**Environmental Impact
Assessment Report for Maple
Road Crossing of Fulton
Creek, Edmonton, Alberta**

Reference: BD17-03 Maple Road Environmental Impact Assessment for the Crossing of Fulton Creek

Thank you for your comments concerning the above referenced report dated February 28, 2017. Stantec has endeavored to provide further clarification, response or additional information regarding the comments as summarized in the attached tables.

Figure No. 1-1

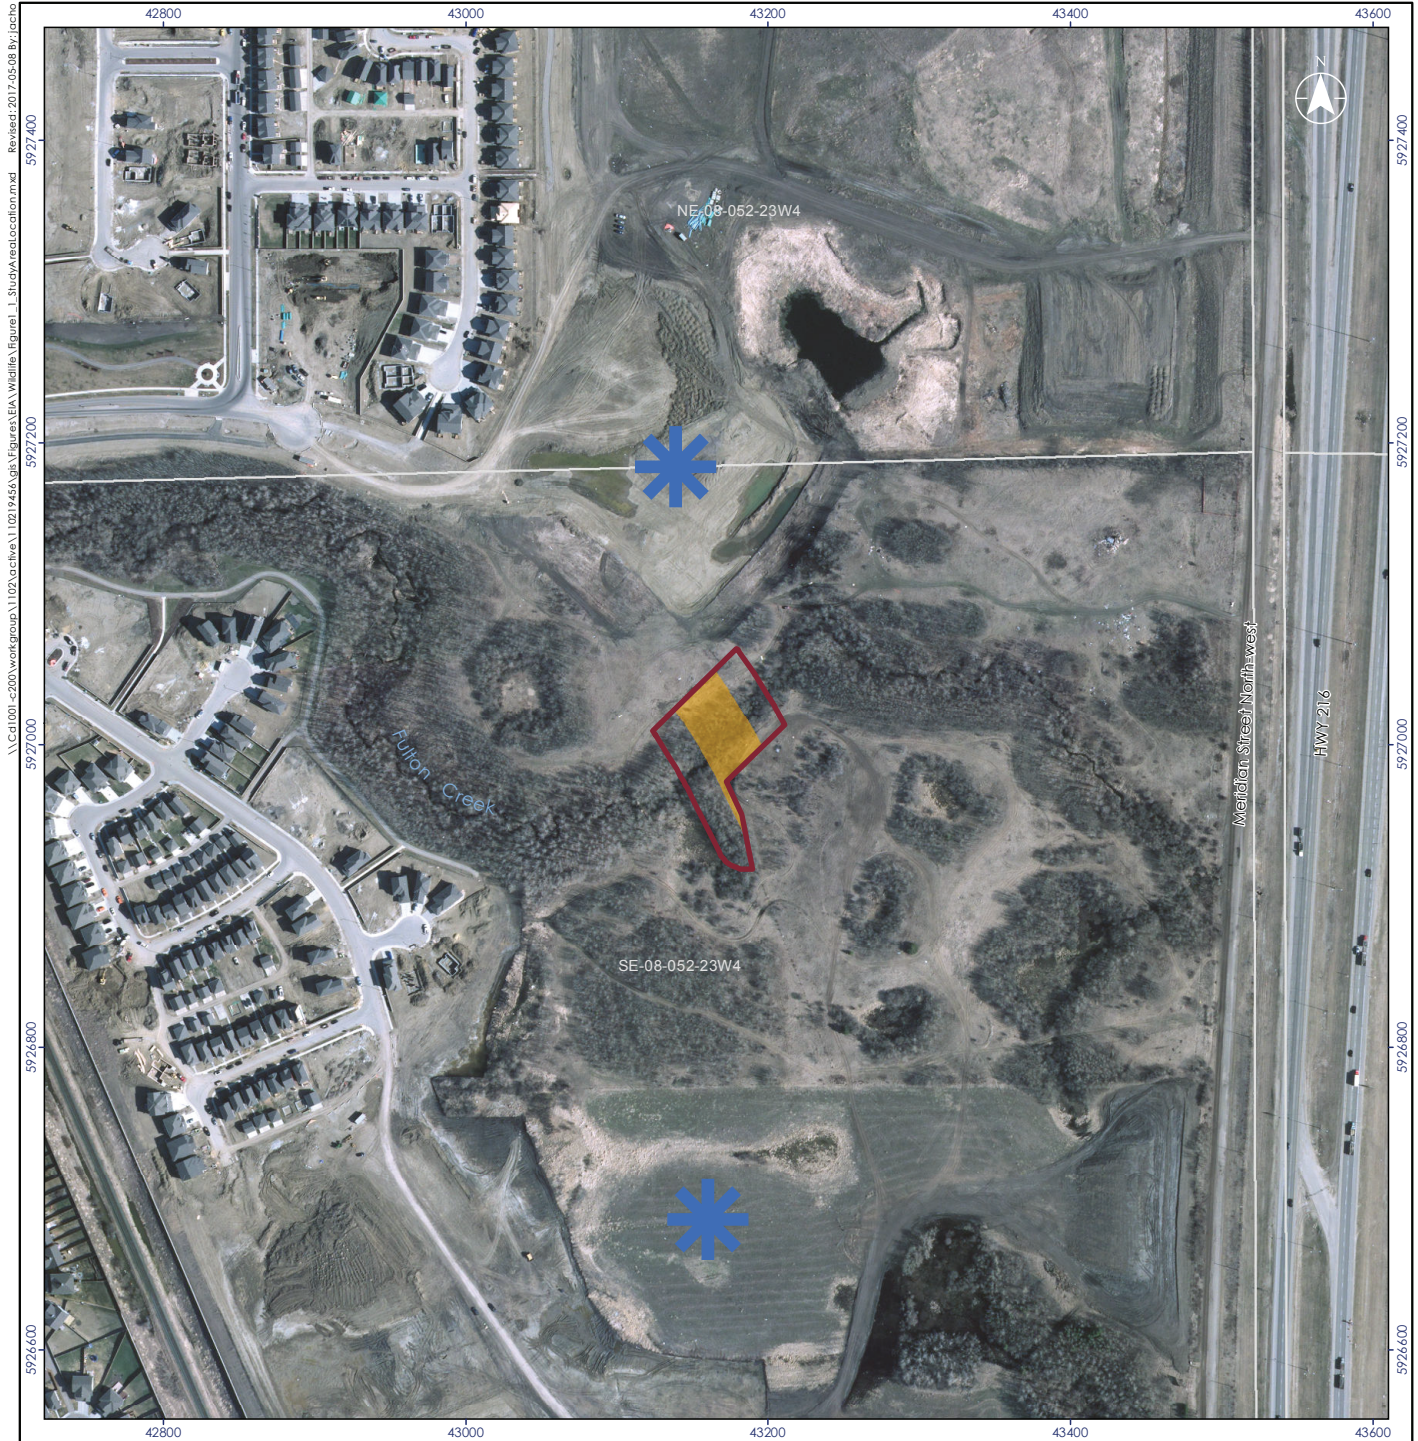
C14.	Diversions plantings on either side of the road to move birds and aerial mammals up and over the road.
A14.	Thank you for your comment, it has been passed along to the design team for incorporation into the detailed design.
C15.	Consider the use of signage and/or reflectors in conjunction with the development of this below grade crossing. This is particularly significant knowing that a longer than average culvert length may prevent use of this passage structure for medium mammals which could result in a greater number of at grade crossings (and increased safety concerns).
A15.	Thank you for your comment, it has been passed along to the design team for incorporation into the detailed design.
C16.	Section 1.1 indicates that this EIA was to "...develop a mitigation plan to identify key areas for avoidance or minimize disturbance..." While the report in many areas reiterates the need to minimize project impact (e.g. page 6.8: "extent of veg. clearing ...should be minimized"), nowhere in the document is it outlined how or where this will be accomplished. Please include a section that outlines the mitigation plan and include a more detailed figure (please also include lay down areas).

A16.	Mitigation measures are outlined within the subsections of each component in Section 6. Figure 1-1 has been updated to improve clarity. Report wording has also been updated in Sections 1.1 and 2.2.
C17.	Please include a project alternatives section which more fully outlines the other culverts considered and the reasons they were not better for the project. In particular, please more fully address the comment that the proposed culvert was selected "due to engineering considerations and efficacy of wildlife passage." In addition to those items, please also speak to impact on hydrology and construction footprint of each alternative.
A17.	Section 2.5 has been added to the report to address this request.
C18.	No detailed on ESC measures are included. Please include ESC measure details.
A18.	An ESC drawing has been provided by the design team and can be found in the revised Appendix A.

A34.	The disturbance area has been added to Figure 1-1 and is also shown on Figure 4-1. The total area being cleared is approximately 0.24 ha. The area being replanted is approximately 0.17 ha.
C35.	Section 6.2: Vegetation/landscaping: <ul style="list-style-type: none"> • Please show on Design Drawings where construction fencing will be placed.
A35.	Construction fencing will be placed at the boundaries of the disturbance/cleared area.
C36.	Section 6.3: Wildlife: <ul style="list-style-type: none"> • Please outline/show how mitigation measures outlined are addressed on the detailed design drawings
A36.	Revised design drawings have been included in the EIA with this submission. These drawings include utilization of non-rip rap ESC material in the creek bed to provide a natural substrate, they do not utilize grates, and they include planting plans with tree plantings in the boulevard and adjacent disturbed ravine.

Project FULTON CREEK UNDER MAPLE ROAD
SIERRA SLOPE

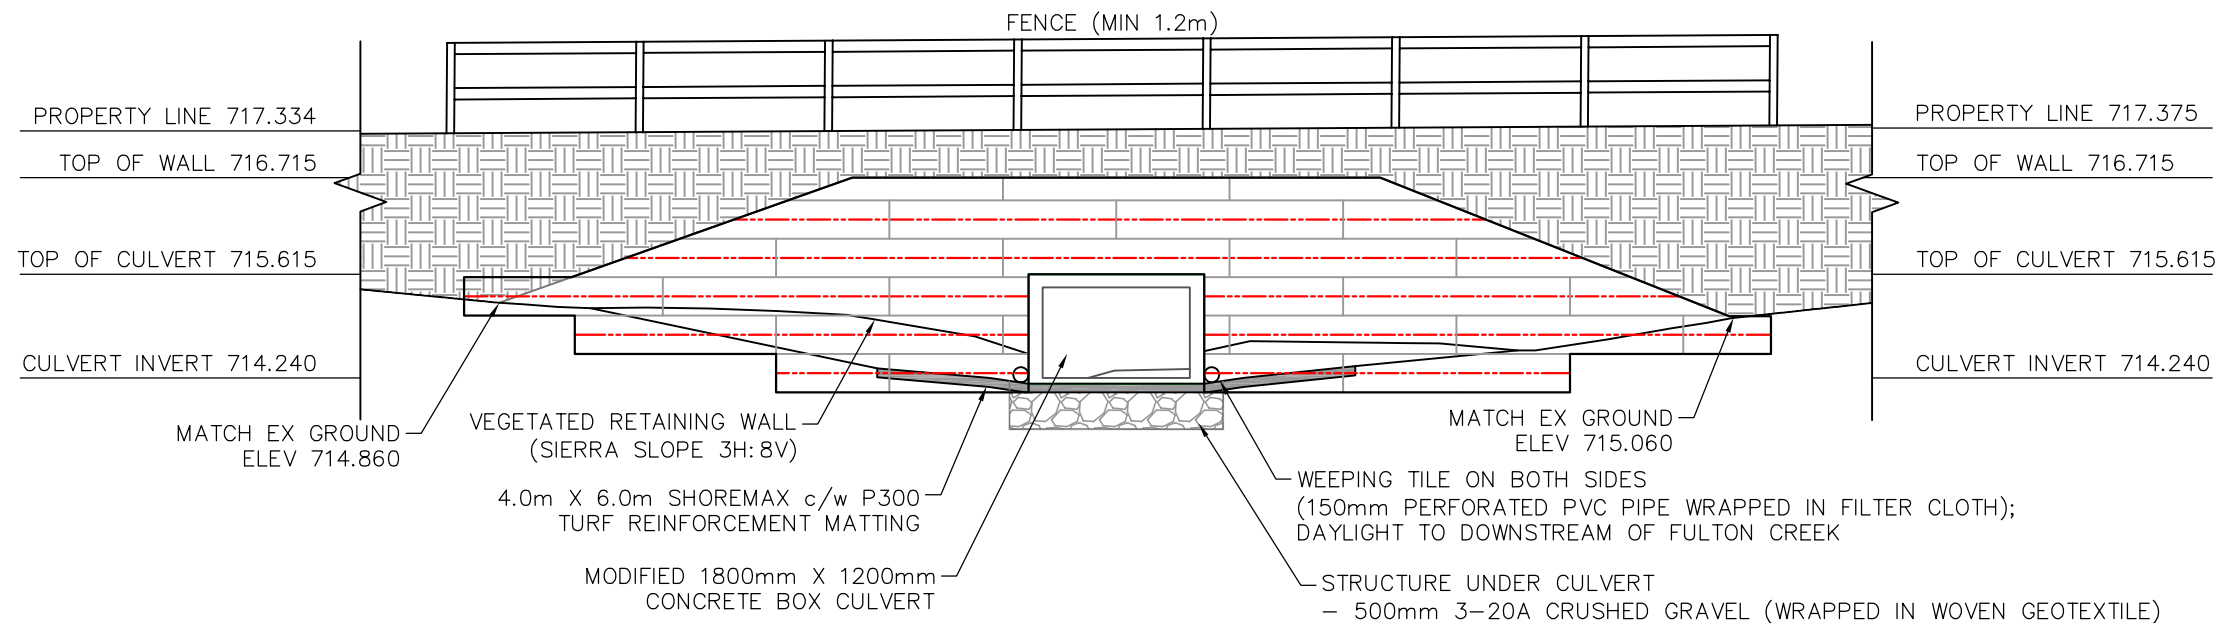
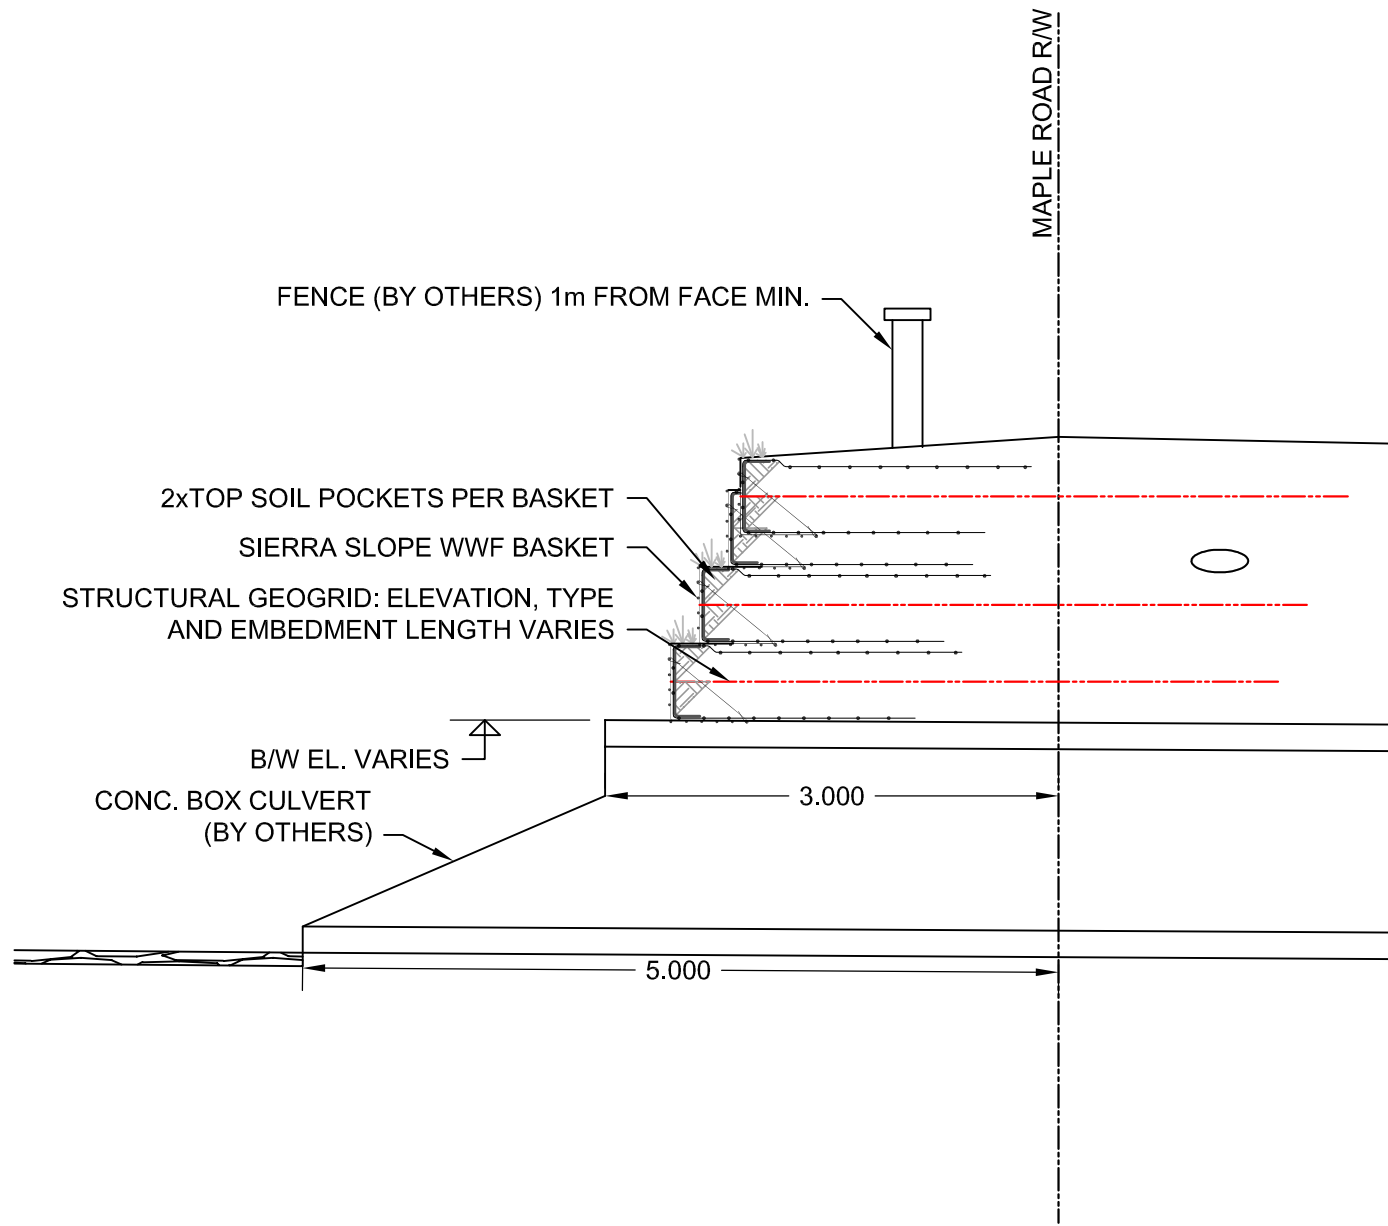
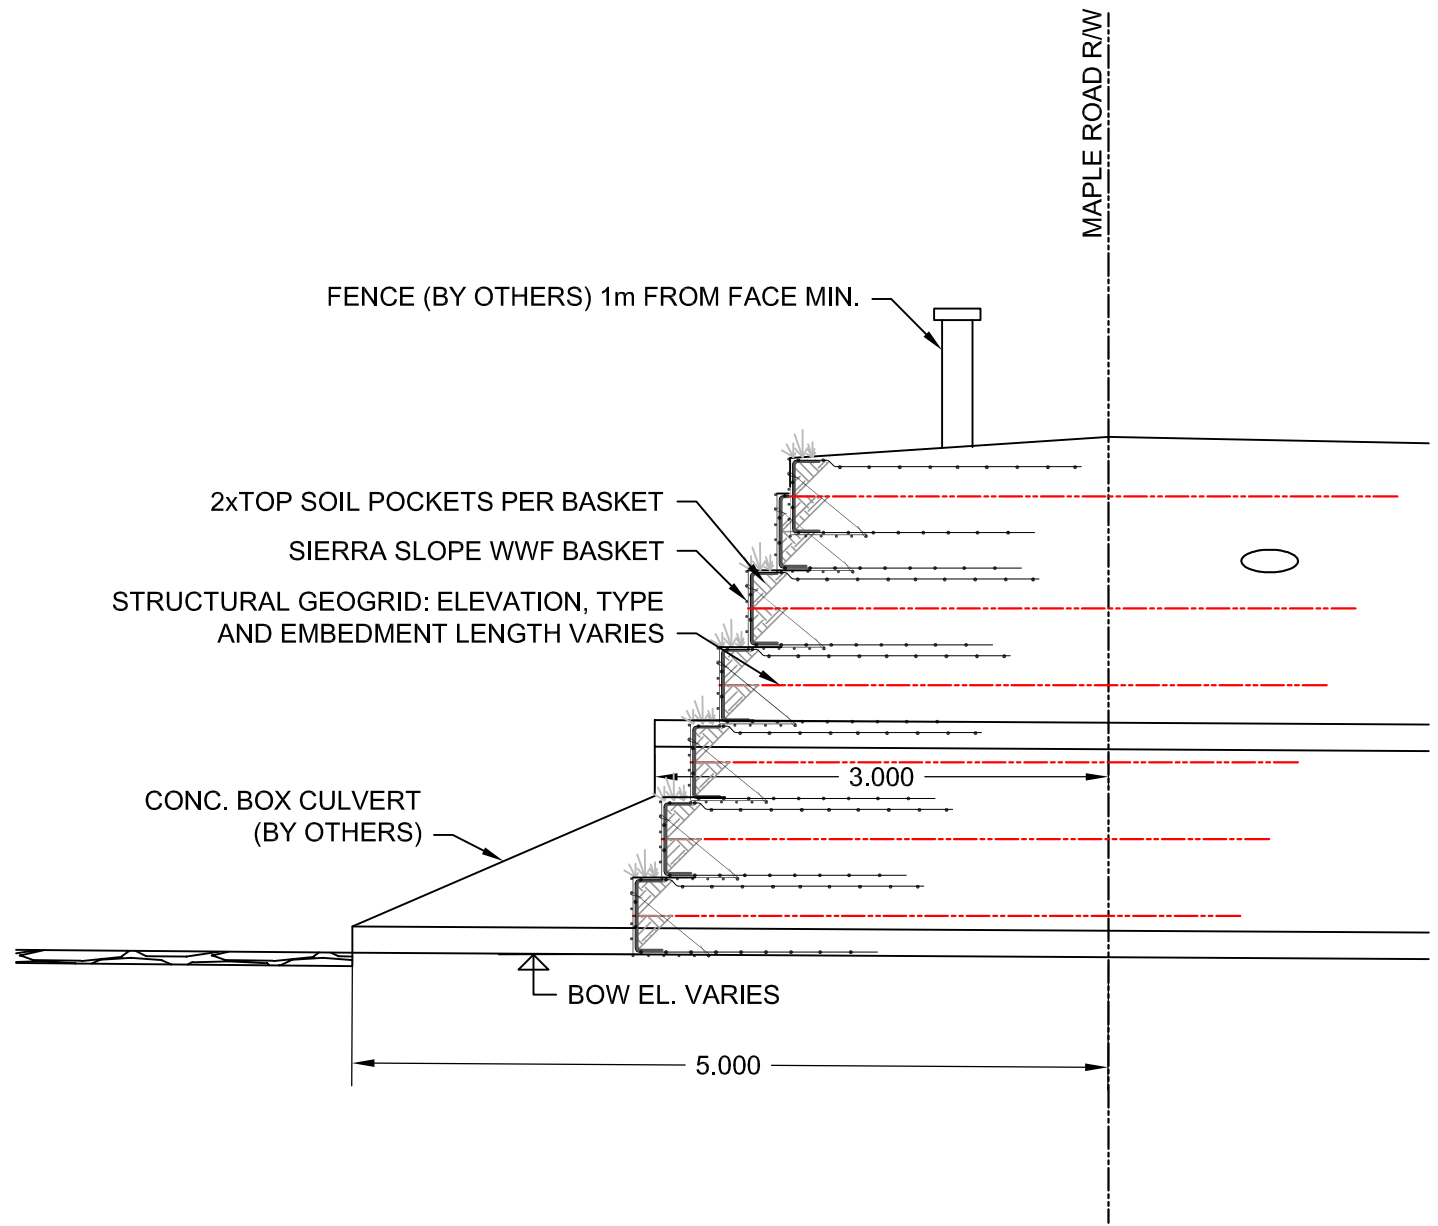
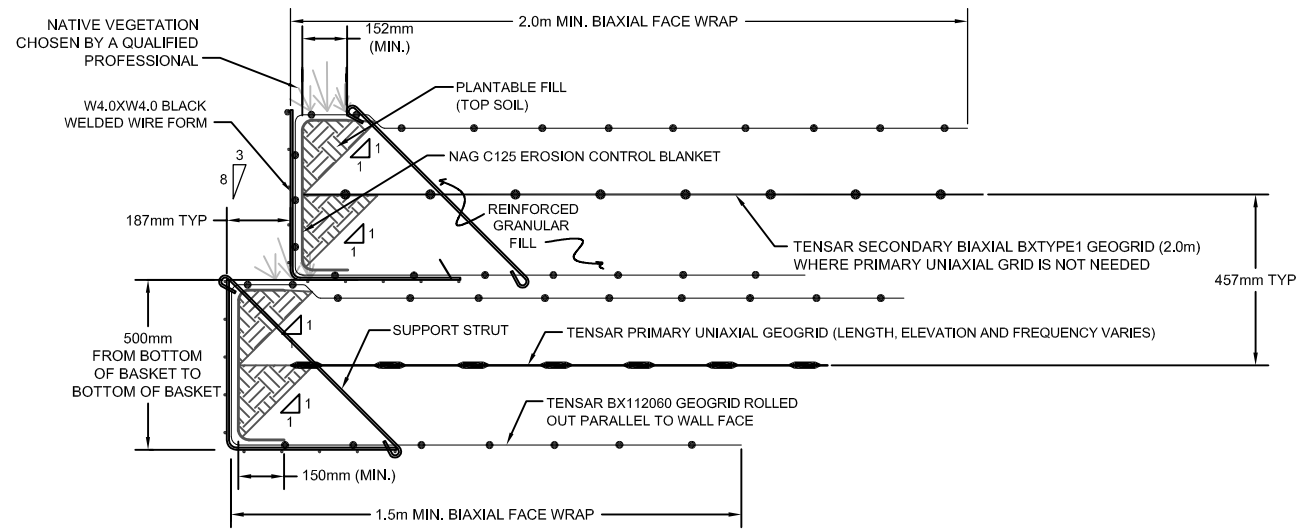
C41.	The Maple Road cross-section and culvert section included on page 48 of the report are consistent with the approved preliminary plan for Maple Road.
A41.	Thank you for your comment
C42.	The retaining wall details included on page 49 of the report have not yet been reviewed by our group. We will review these details with the detailed engineering drawing submission and they will also be referred to the City's structural and geotechnical groups for review.
A42.	Thank you for your comment.

- 1) Overall, the retaining wall design as presented in the Tensar/Nilex design drawings appears to be of a suitable engineered nature for the roadway construction over the box culvert/wildlife crossing, as does the erosion control use of the 'Scourshield';
- 2) The granular backfill utilized within the roadway reinforcement should consist of a clean gravel (such as City of Edmonton Designation 3-20A (20 mm crushed gravel)), placed and compacted to 100% Standard Proctor Density, to be additionally reviewed and approved by the retaining wall designer;
- 3) Additional supporting technical discussion of the retaining wall reinforcement and erosion control product as requested by the City of Edmonton should be provided as part of detailed by the Tensar design engineer.

Figure 6. Modified 1800mm x 1200mm box culvert detail (from Figure 2).

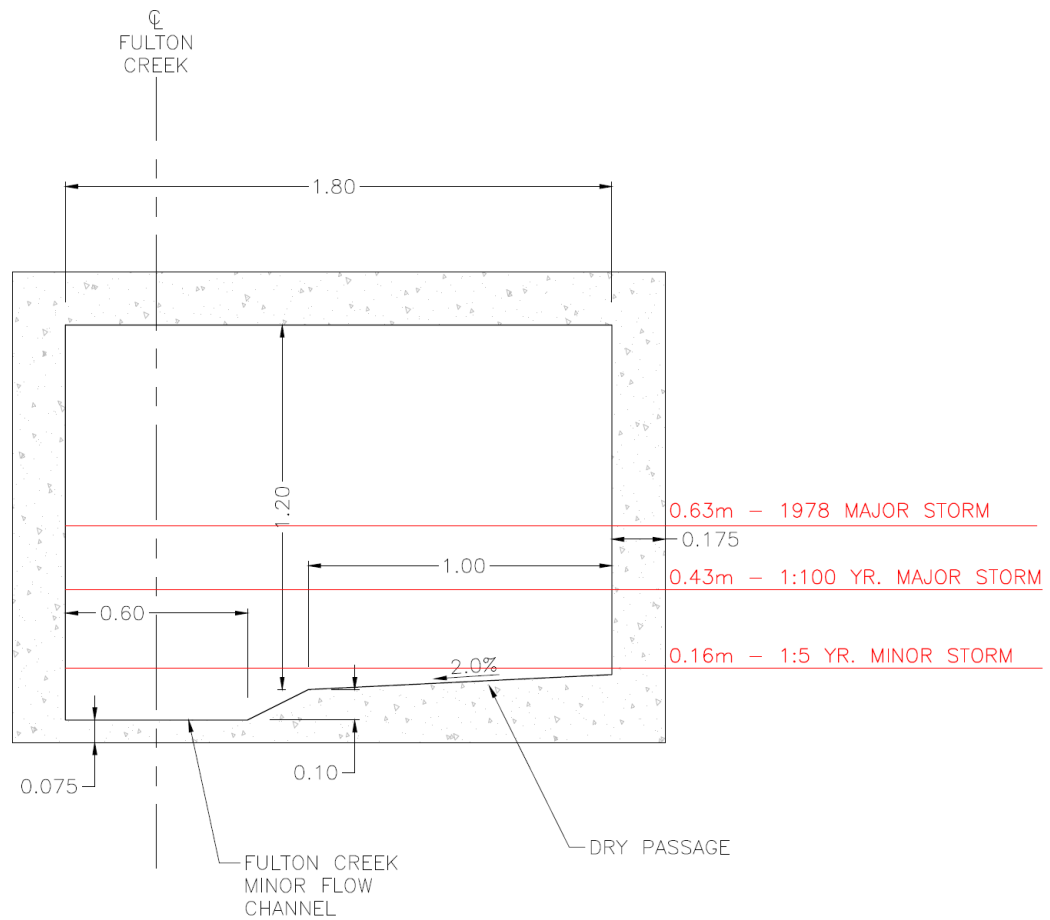
C6.	<p>We are concerned that the proposed openness ratio is inadequate for this crossing. Research summarized in the Wildlife Passage Engineering Design Guidelines outline that the minimum openness ratio that the design should be aiming for is 0.4. Currently, the proposed closed bottom box culvert has an openness ratio of 0.04 – more than 10 times less than the minimum required (more at high flow). This issue needs to be addressed either through increasing the opening area, decreasing the culverts length, or ideally a combination of both.</p>
A6.	<p>As discussed in our meeting on April 6, 2017, the passage was designed for the small terrestrial and amphibian ecological design groups (EDGs). The guidelines on openness quoted in the comment above are for the medium terrestrial EDG. We understand that there may have been some confusion regarding what EDGs the passage was being designed for. As discussed in our meeting, we have gone through the EIA and clarified that the passage was designed for small mammals and amphibians, and that the medium terrestrial design group is expected to cross the road at grade.</p>

C7.	<p>It is currently unclear how much space would be available on the sides of the channel that carries water for terrestrial mammals to traverse – particularly in the spring freshet or during an extreme rain event. Widening the culvert may assist in resolving this issue. Please outline terrestrial wildlife use of this structure.</p>
A7.	<p>During extreme rain events the culvert will not facilitate dry passage. However, the culvert does remain functional during regular base flows and smaller events (e.g. 1:2, 1:5 year storms).</p>
C8.	<p>Note that terrestrial wildlife prefers a natural substrate to walk across, indeed, open bottom culverts are preferred to closed bottom culverts.</p>
A8.	<p>Unfortunately, an open bottom culvert is not feasible at this location due to topographical and engineering constraints. There is not enough topographic relief in this ravine to install an open bottom culvert without elevating the roadway, and this is not possible without significant alterations to infrastructure already constructed in the area. The major drainage flows in this neighbourhood are designed to flow north down Maple Road across this creek crossing towards Fulton Marsh. If the crossing were to be elevated, these flows would need to be diverted south towards 8 Street, then back to Fulton Marsh. Portions of 8 Street are already constructed along with housing with residents already in place. Such a re-direct of flows would require redesign and reconstruction of the existing infrastructure, which would be both costly and disruptive to the local residents.</p> <p>As a mitigation measure for utilizing a concrete box culvert, we are proposing to “brush” the concrete bottom. This will create a roughness that will likely trap a thin layer of</p>
